TECHNICAL REPORT

Diving Facilities for Balkan Junior Games in Bakau Romania 2015

G.Fyrigou Consolo, LEN TDC Chairman was requested by the President of the Romanian Federation to make a site visit in Bakau (ROM) on the occasion of the forthcoming Balkan Junior Games for Age Groups(A-B-C) categories , **March 27-29, 2015**

Photos: G.Fyrigou Consolo_6.12.14

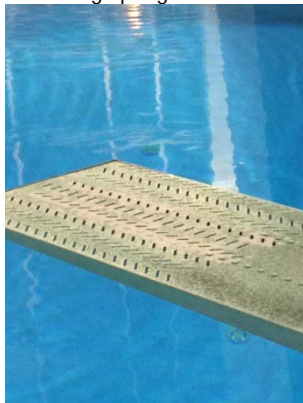
- The 1m Springboards must be substituted with new springboards since their surface has been destroyed and is dangerous for the divers to perform dives

Please see photos of the existing springboards

Photos by G.Fyrigou Consolo_6.12.14

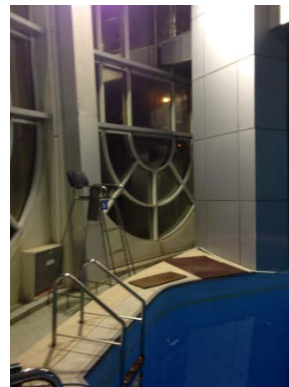
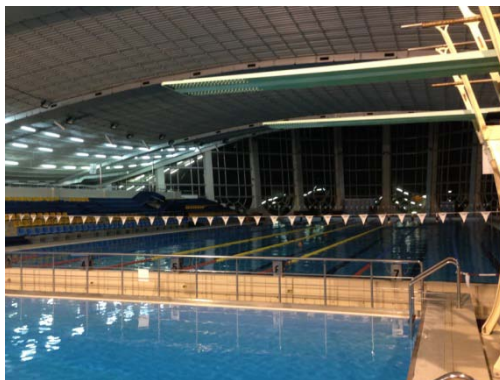
- The stairs for the 5m -7.5m and 10m must be dressed with non slippery material as the stair for 3m.
- Please see below photos of the existing stairs coverage
